APPLICATION FOR A CERTIFICATE OF APPROPRIATENESS – STAFF REPORT

COA-0077-2019518 ELM STREETApplicant:STEVEN VALENZIANO FOR AEDAN WORKSHOPReceived:7/10/2019Submission date + 90 days:10/8/20191) 9/26/20192)3)

<u>Nature of Project</u>: Resurface and edge existing driveway and walkway; remove and replace fence and gate with both 4' and 8' fence; install walkway, patios, steps; modify deck Staff Notes:

4137 South Alston Avenue Durham, North Carolina 27713 919.819-2989 | 919.523.1842 www.AEDAN.com 0 く ч С ¥ Ш Œ 0 \checkmark ≥ Bronstein Residence Kate Bronstein 518 Elm Street Raleigh NC 27604 by: Clark šä Avcc nes Ъ Га Scale: as noted Sheet Size: 11x17 PLOT PLAN DETAIL (EXISTING)

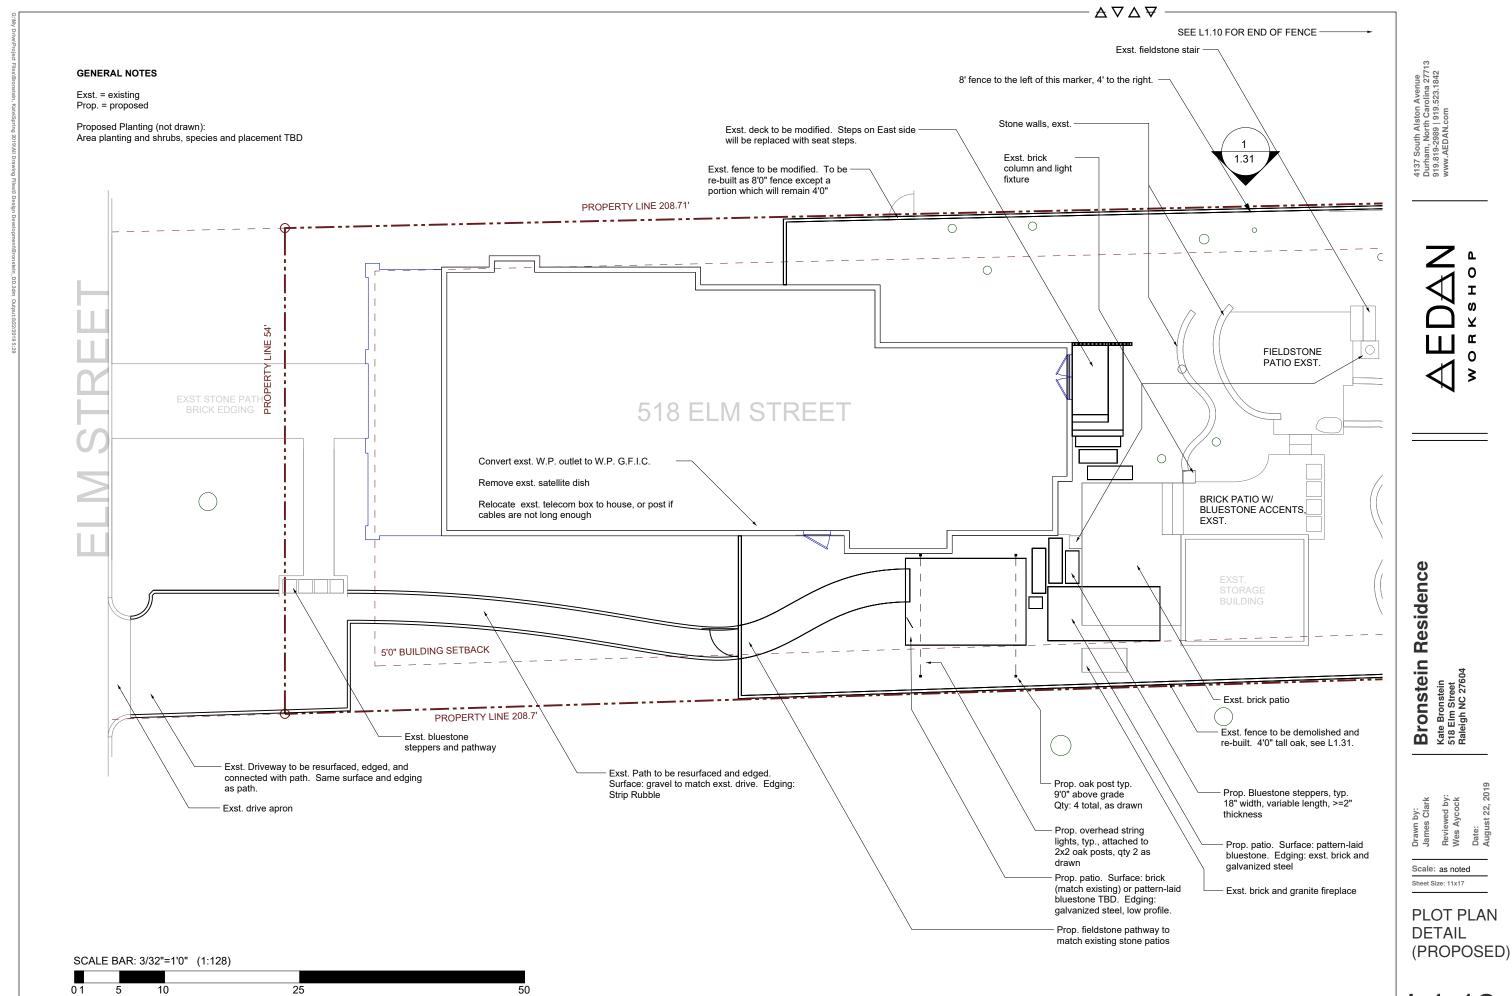
18* The existing site plan (drawing L1.11) includes a note about the relocation of a telecom box to the house or a post. No specific details were provided on the location.

- a. Photographs of the strip rubble edging;
 - b. Telecom box;
 - c. Fence paint or stain color swatches from paint manufacturer.

DECK MODIFICATIONS

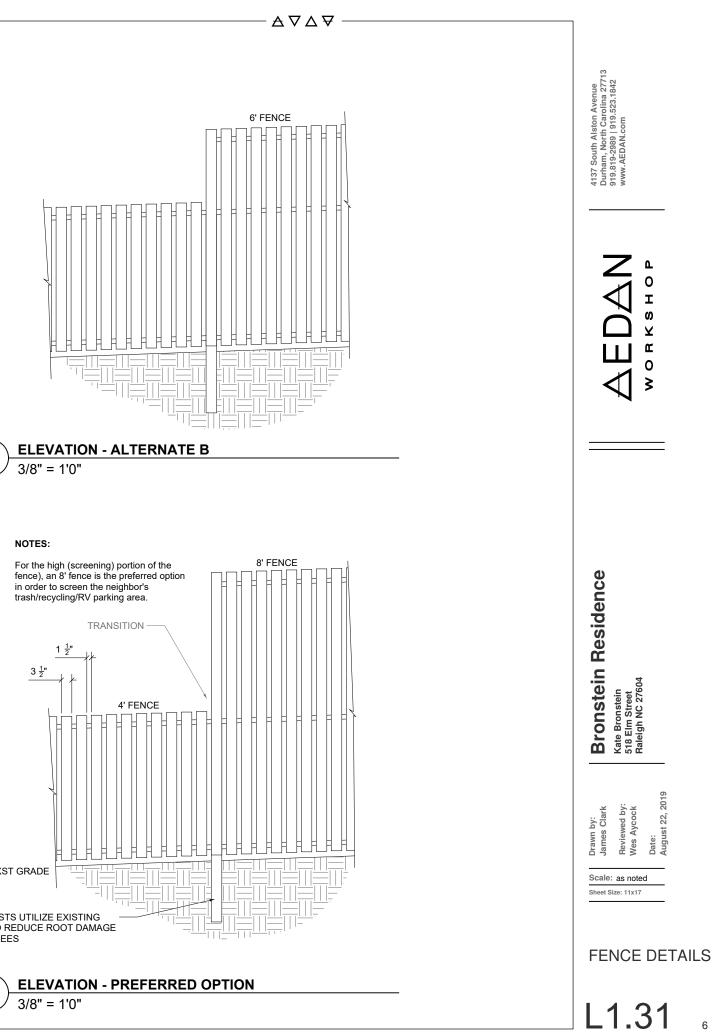
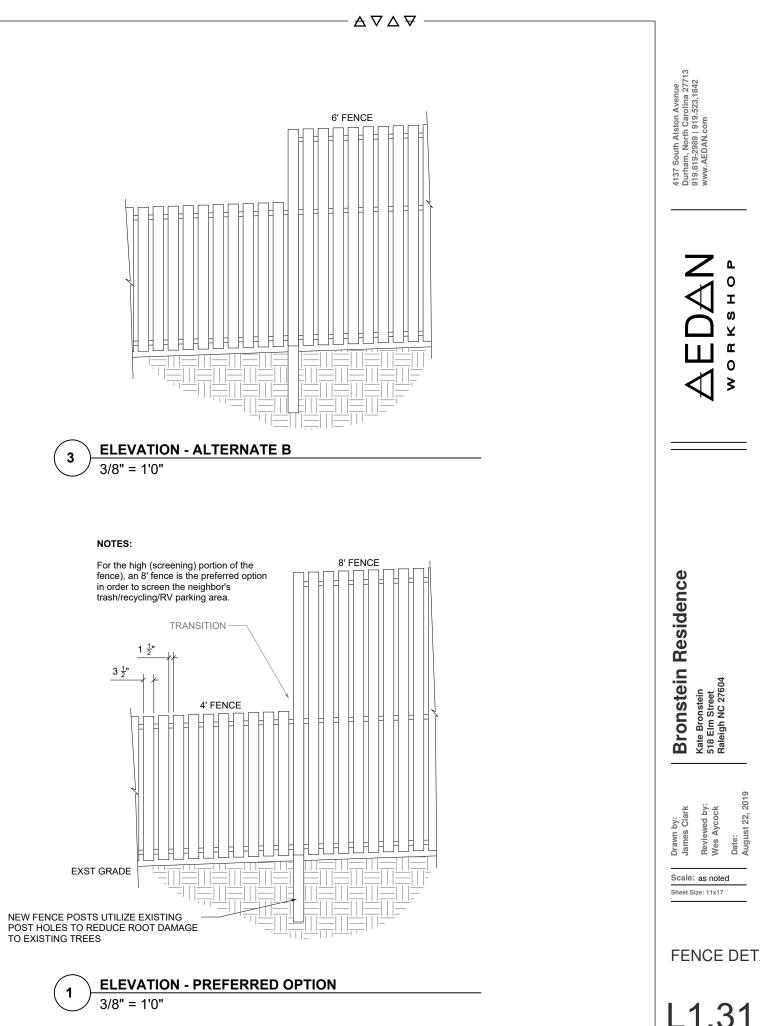
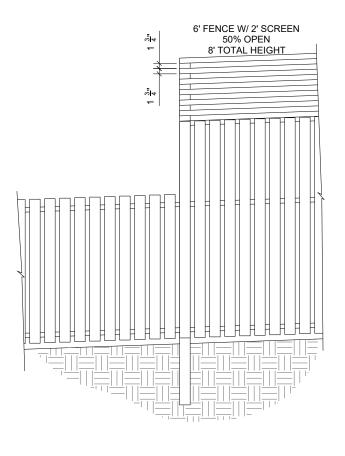
- 17* The application includes a modification to the existing deck, removing the east steps to create seat steps. Detailed drawings were provided.

ELEVATION - ALTERNATE A 2 3/8" = 1'0"

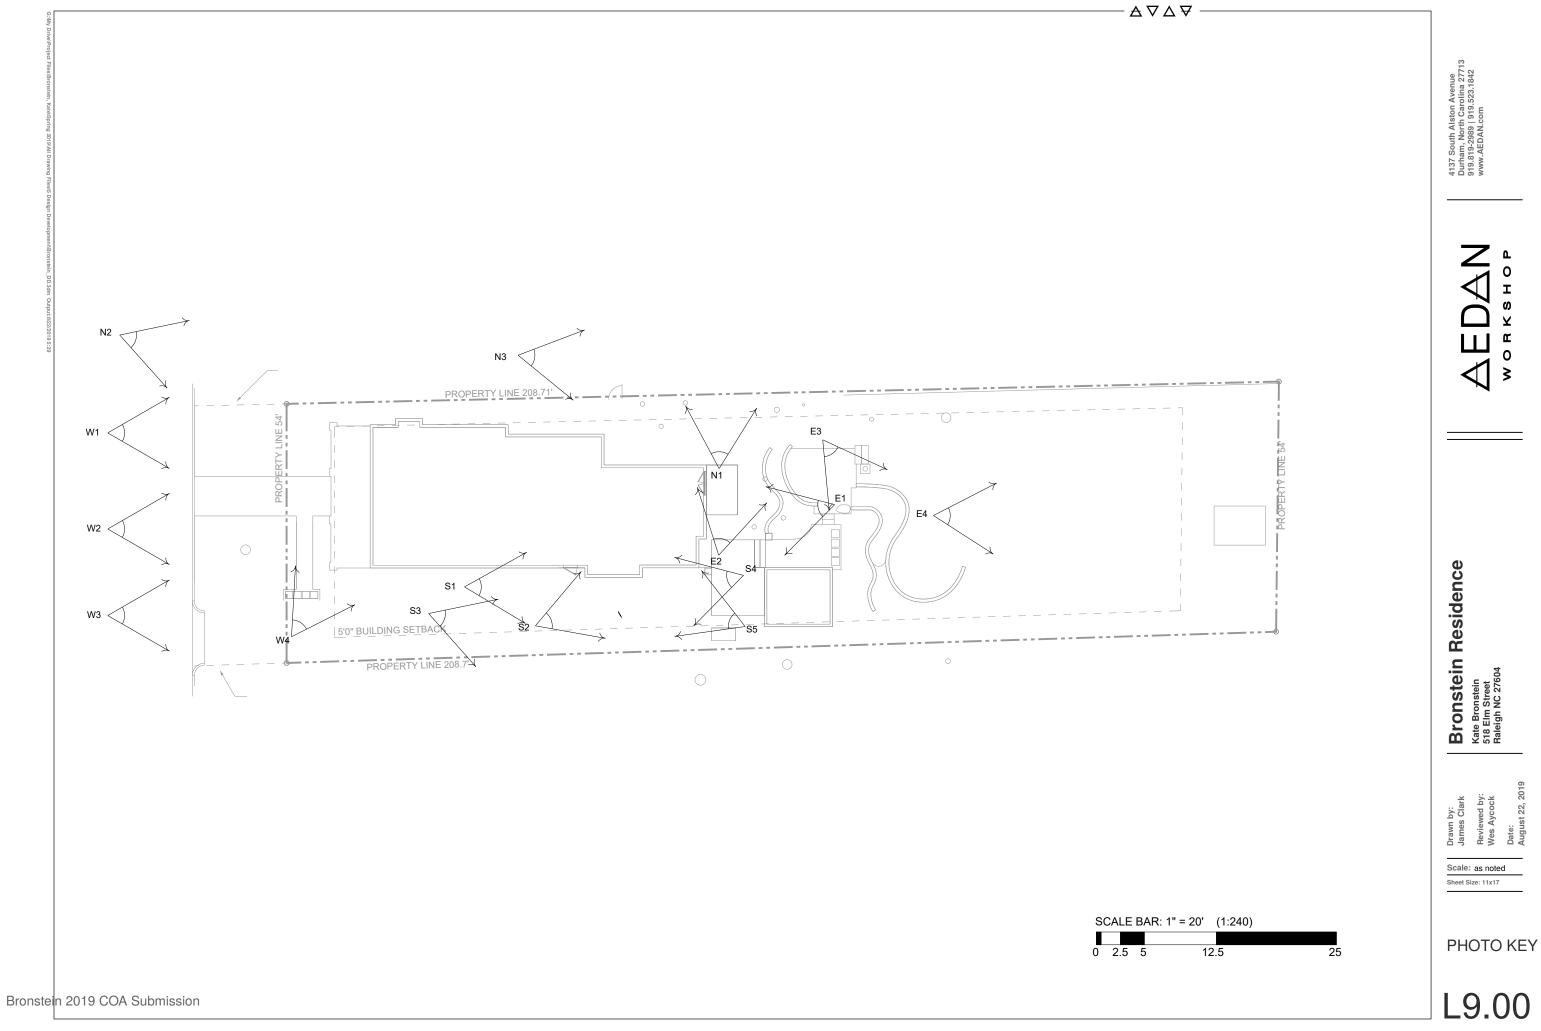
- 15* Detailed elevation drawings were provided for the fencing, including two alternatives. No drawings were provided for the gate or a section view of the fence. Fence finish details were also not provided.

- b. An updated site plan showing the heights of all fencing;
 - c. Final fence and gate elevation and section drawings;
- 5. That detailed drawings and/or specifications for the following be provided to and approved by staff prior to installation or construction:
